**CROYDON COUNCIL**

**DECISION NOTICE: Traffic Management Matters by Cabinet Member for Sustainable Croydon**

<b>REPORT TO:</b>	<b>Traffic Management Advisory Committee</b> <b>7 July 2021</b>
<b>SUBJECT:</b>	<b>Objections to Proposed Introduction of Waiting &amp; Loading Restrictions</b>
<b>LEAD OFFICER:</b>	<b>Sarah Hayward, Interim Executive Director of Place</b>
<b>CABINET MEMBER:</b>	<b>Councillor Muhammad Ali, Cabinet Member for Sustainable Croydon</b>
<b>WARDS:</b>	<b>Coulsdon Town, Crystal Palace &amp; Upper Norwood, Fairfield, Shirley South and Thornton Heath.</b>
<b>CORPORATE PRIORITY/POLICY CONTEXT:</b>	
<p>This report is in accordance with objectives to improve the safety and reduce obstructive parking on the Borough's roads as detailed in:</p> <ul style="list-style-type: none"> <li>• Croydon Local Plan – Feb 2018</li> <li>• Local Implementation Plan 3; Section 2 Croydon Transport Objectives</li> <li>• Croydon's Community Strategy; Priority Areas 1, 2, 3 &amp; 4</li> <li>• The Croydon Plan 2<sup>nd</sup> Deposit; T4, T7, T35, T36, T42 and T43</li> <li>• Croydon Corporate Plan 2015 – 18</li> <li>• Croydon Parking Policy 2019 – 22; Section 2</li> <li>• <a href="http://ww

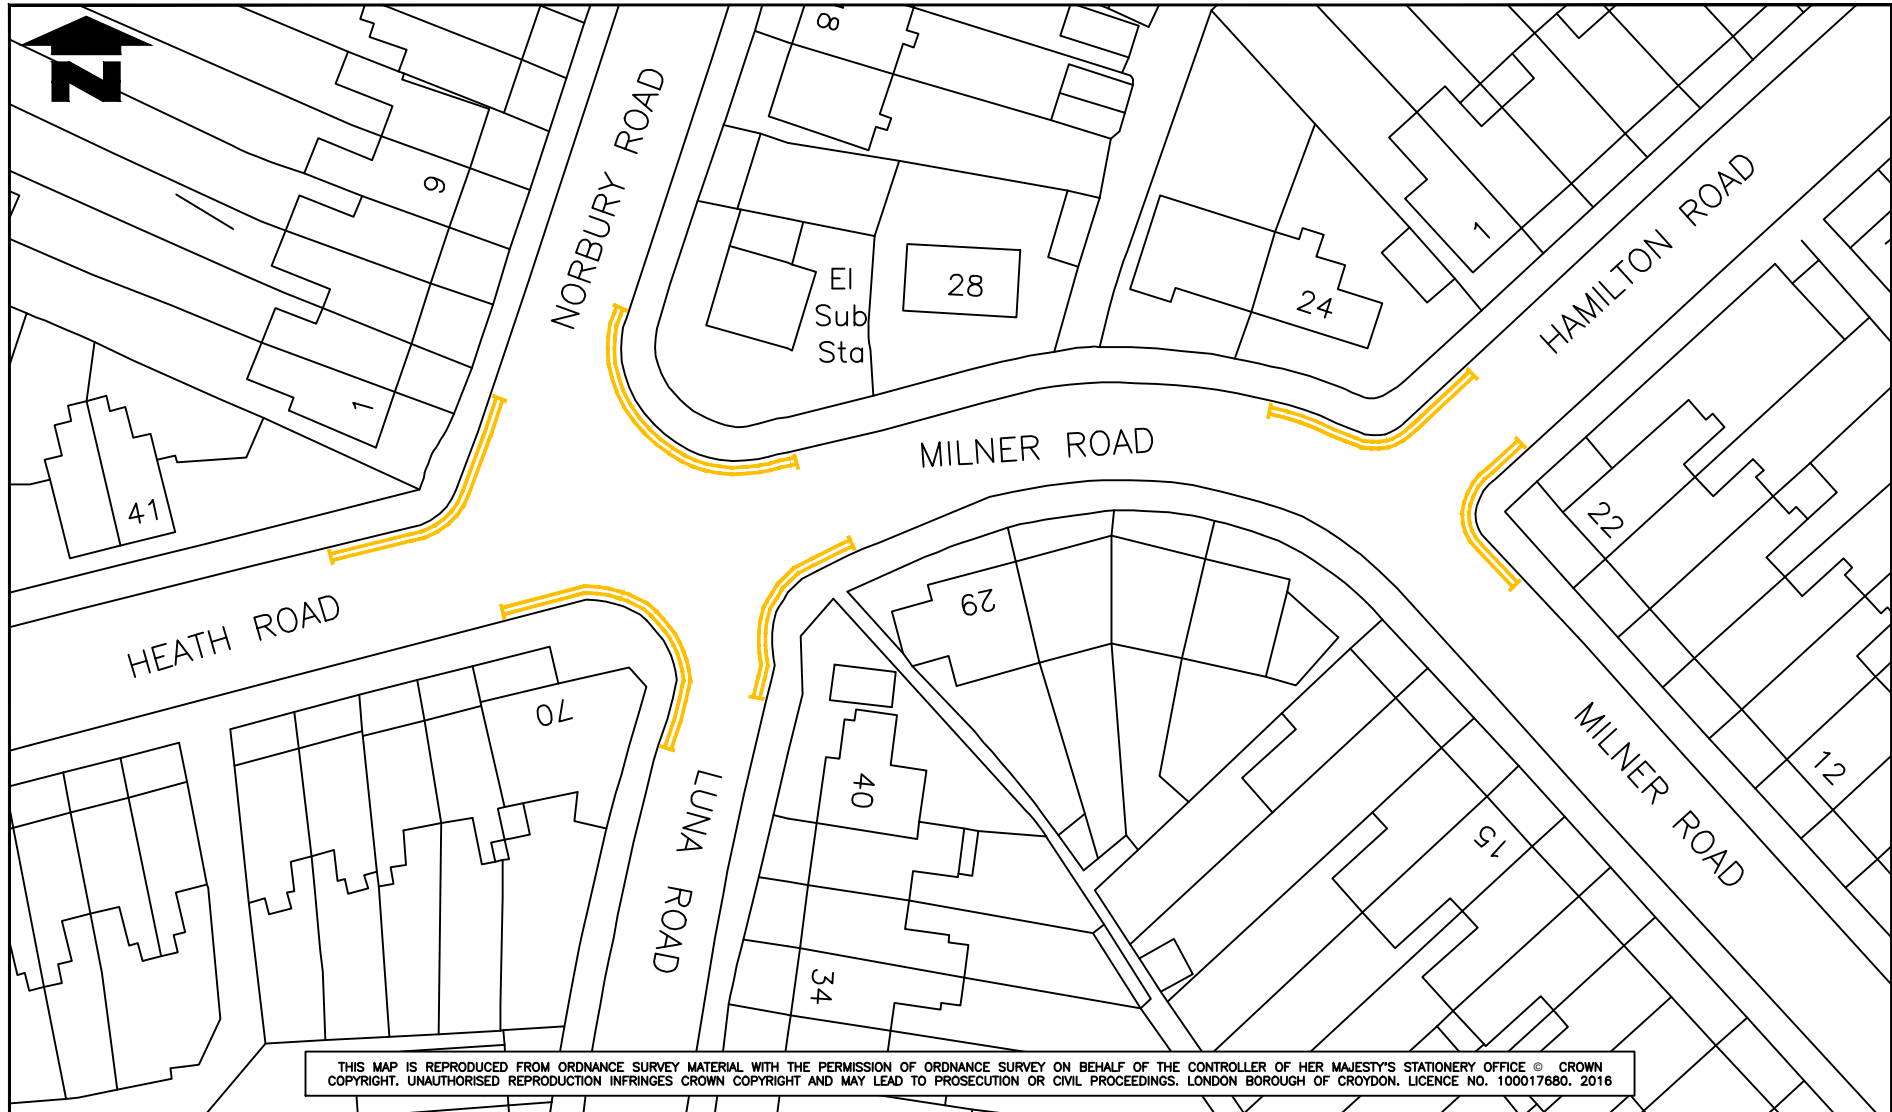
An objection was received to the proposed "at any time" waiting restriction at this junction. The objection was raised by a resident on the grounds that:

- The double yellow line should extend across the entry gates to our property to protect access and it should continue for a minimum one meter after our gates, for us to be able to go in and out.

Ten metre lengths of double yellow line were proposed at either side of this junction in accordance with the recommendation contained in the Highway Code that vehicles should not be parked within ten metres of a junction unless they are within an authorised parking bay. However, it is recognised that the proposed double yellow lines do not extend across the resident's vehicular access, and consequently there is a possibility that vehicles displaced from parking at the junction by the restrictions would block the resident's driveway. In view of this, it is proposed to extend the proposed double yellow lines across the vehicular access in Ryefield Road, as shown in amended drawing No. PD424e. It is not proposed to extend the restrictions for a further metre across the neighbouring property, as suggested by the objector, as the amended restrictions should be sufficient for safe access and egress.

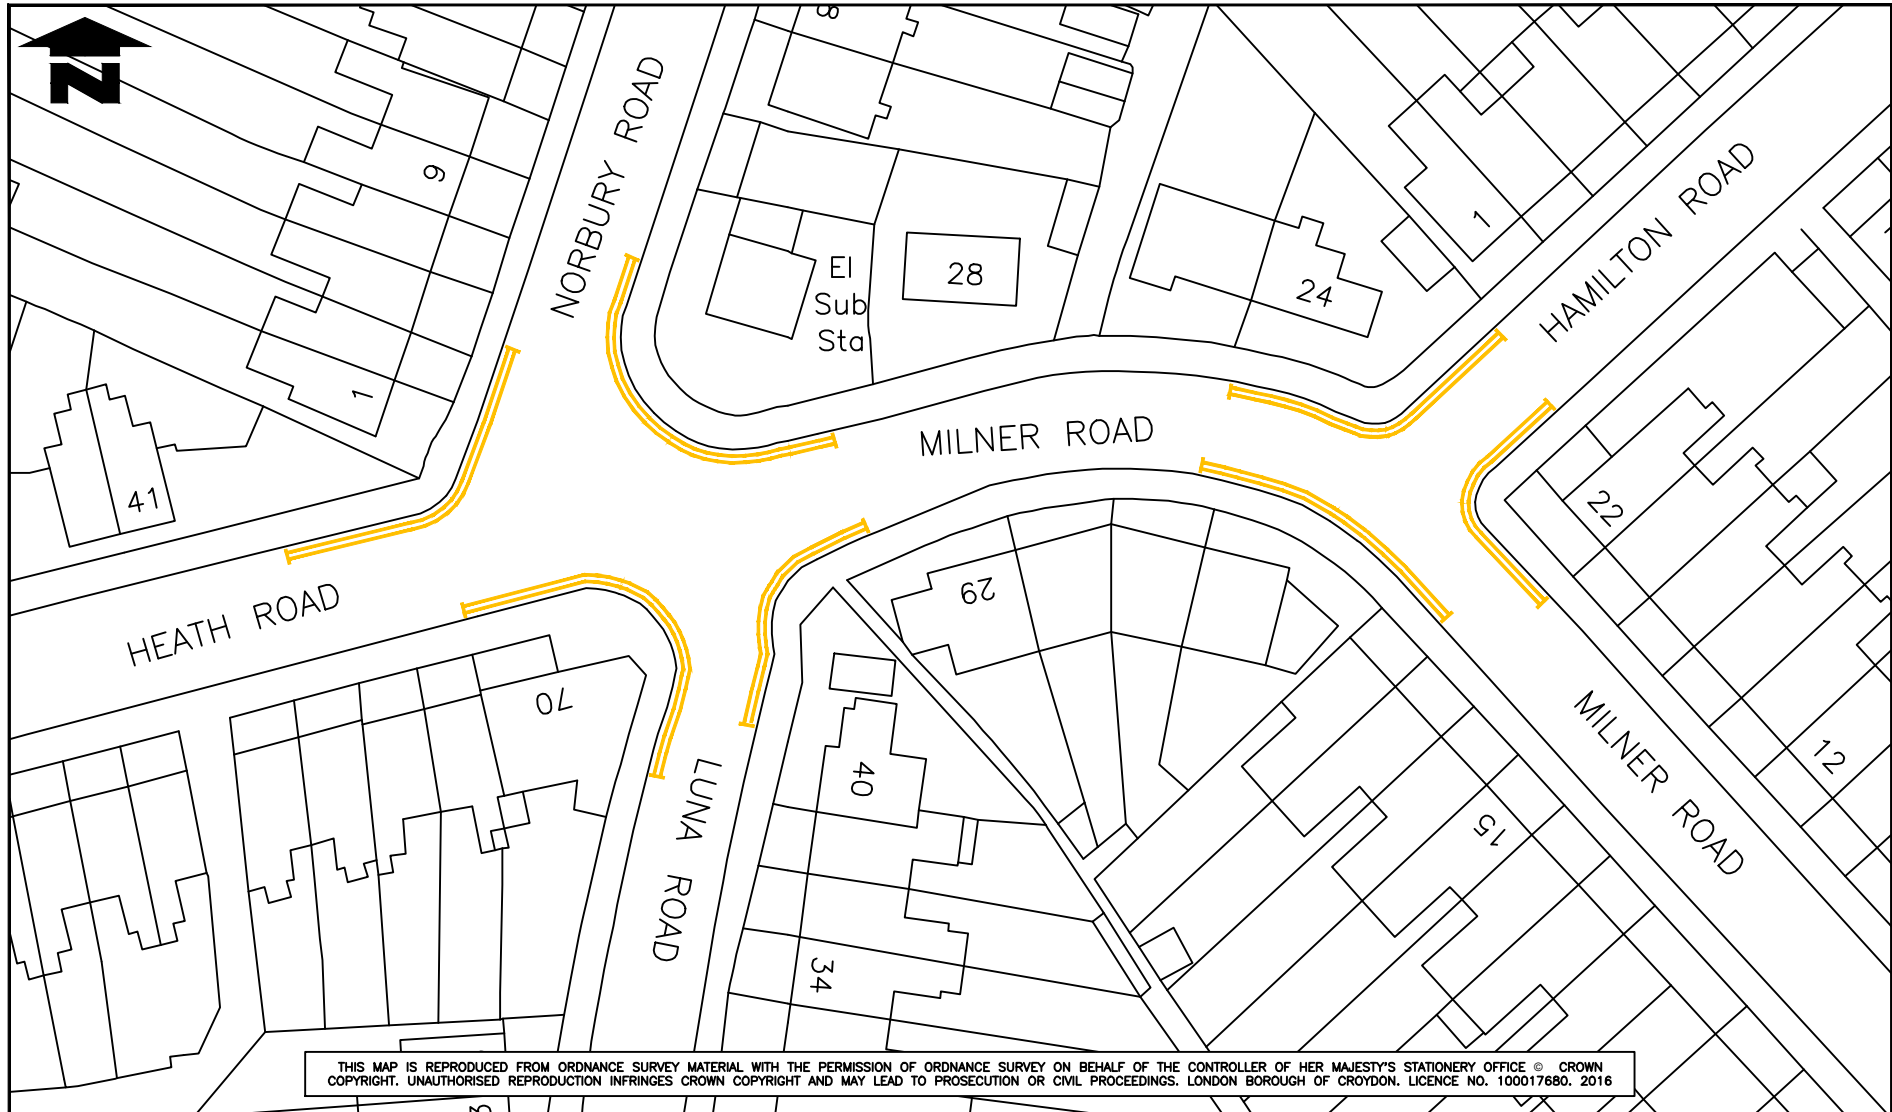
An objection was received to the proposed "at any time" waiting restriction at this junction. The objection was raised by a resident on the grounds that:

- The proposed restrictions will reduce parking spaces and cause friction between residents
- The proposals should be sign-posted publicly

Five residents objected to the proposed "at any time" waiting restrictions at these junctions. The objections they raised were on the grounds that:

- The proposed restrictions will reduce parking spaces and cause friction between residents.
- The lengths of restriction are excessive.
- Where will delivery vehicles park if these restrictions are introduced?
- There do not seem to be any current parking issues – why are these restrictions being proposed?
- Who would want to buy a house with double yellow lines across the frontage?

The proposed ten metre lengths of double yellow line at this junction were put forward in response to complaints of obstructive parking. Whilst it is accepted that the proposals would reduce the amount of available parking space, this only affects locations close to corners where drivers are recommended not to park by the Highway Code. However, in response to the objector's concerns about preserving as much parking space as possible, it is proposed to reduce the restrictions from ten to seven metres at this junction as shown in amended drawing No. PD424m.

The restrictions are confined to junctions and bends in Milner Road where parking is not ideal, and have been proposed in response to complaints about obstruction, safety and access concerns in these locations. The lengths of the proposed restrictions were considered to be a proportionate response to the problems reported by complainants. Whilst double yellow lines prohibit waiting at any time, they do not prevent vehicles from stopping on them for loading and unloading purposes for up to forty minutes, so delivery vehicles would not be affected. There is no evidence to suggest that parking restrictions affect house prices and they can often be perceived as a positive thing, protecting access and sightlines and preventing obstruction.

4.9 However, in view of the strength of feeling expressed by the residents and in order to reduce the impact on available parking space, it is proposed to reduce the proposed restrictions to seven metres in length at all junctions and to remove the double yellow lines in Milner Road opposite the junction with Hamilton Road from the proposals, as shown on amended drawing No. PD424m.

HIGHWAY IMPROVEMENTS - PARKING DESIGN			
Scale: 1:1000	Drawn TOR	Checked DW	Rev. 00
Date:	AUGUST 2020		Drawing Ref. PD 430c

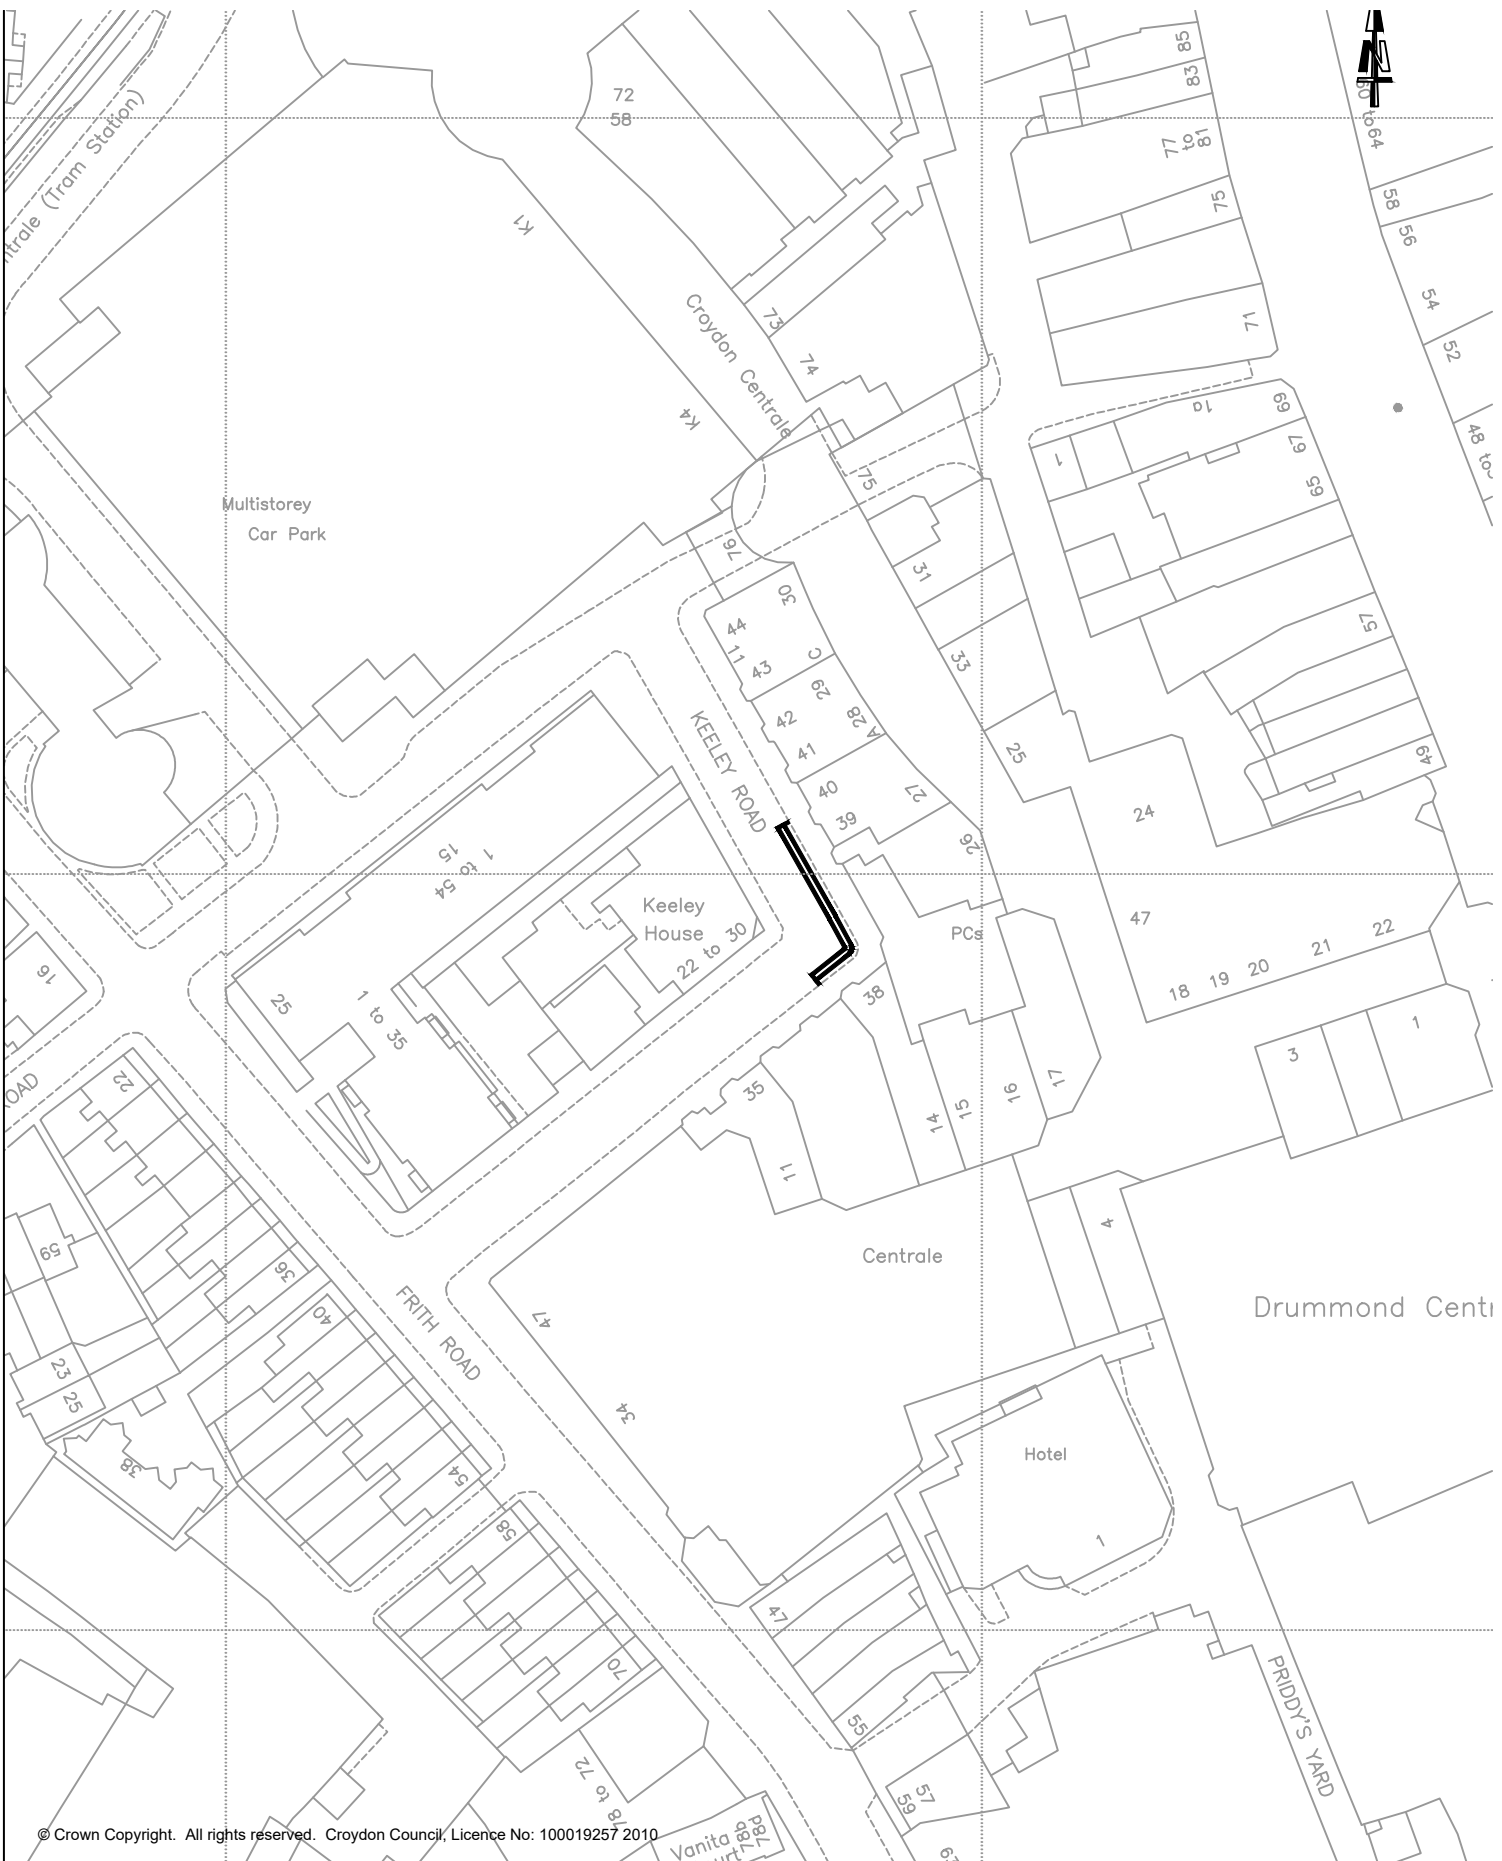
An objection was received to the proposed "at any time" waiting and loading restrictions outside Nos. 38 and 39 Keeley Road. The objection was raised by a Community Centre based in Keeley Road on the grounds that:

- They are based next to the accessible entrance to the Centrale Shopping Centre and have many user groups with access limitations (e.g. wheelchair users, blind groups and adults with learning difficulties and Autism) who benefit from ease of access via the lift in Centrale, which is close by, and also by being close to the street entrance where they can be dropped off and picked up by carers or family members. They also have domestic violence survivors attending recovery sessions who benefit from the reduced risk from their perpetrators by arriving and leaving by the front door and being able to be dropped off close by.

- They run a foodbank with food parcels delivered on Mondays and Tuesdays and volunteer drivers to deliver the food. Deliveries and collections require a brief ten to twenty minute period to load/unload outside the front door.

The upgraded waiting and loading restrictions in Keeley Road were proposed following a site meeting with a representative of the Centrale Shopping Centre, who was concerned that parking either side of their goods entrance was obstructing access and egress for large delivery vehicles. The current restrictions in Keeley Road operate from 8am to midnight, Monday to Sunday (waiting) and from 9am to 5pm, Monday to Sunday (loading). During the loading restrictions vehicles should not be parking on the yellow lines, even to load and unload goods, and disabled Blue Badge holders are also prohibited from parking. As a result of the site meeting, it was proposed to upgrade both sets of restrictions to operate "at any time".

4.12 Whilst the proposed loading restrictions would prevent vehicles parking, even to load or unload, they would not prevent vehicles stopping whilst dropping off or picking up a passenger. This means that vulnerable and disabled visitors would still be able to be dropped or collected at the front door of the Community Centre.

4.13 However, in view of the other issues raised by the objector, it is proposed to abandon the proposal for extended loading restrictions and to proceed with the upgrading of the existing single yellow line to double yellow lines only. This will mean that drivers loading or unloading their vehicles will continue to be permitted to park outside the Community Centre to do so before 9am and after 5pm, as they are now, which should assist collections and deliveries of food parcels for the food bank. Disabled Blue badge holders will still be able to be dropped off and collected in front of the Community Centre between 9am and 5pm, when the loading restrictions are in force, but will be prohibited from parking there for any longer than this process takes during these times. It is hoped that the upgraded waiting restrictions will deter parking outside of the times when loading restrictions are in force, in order to assist Centrale's large delivery vehicles by keeping the area near the entrance clear. The amended proposals are shown in drawing No. PD430c.
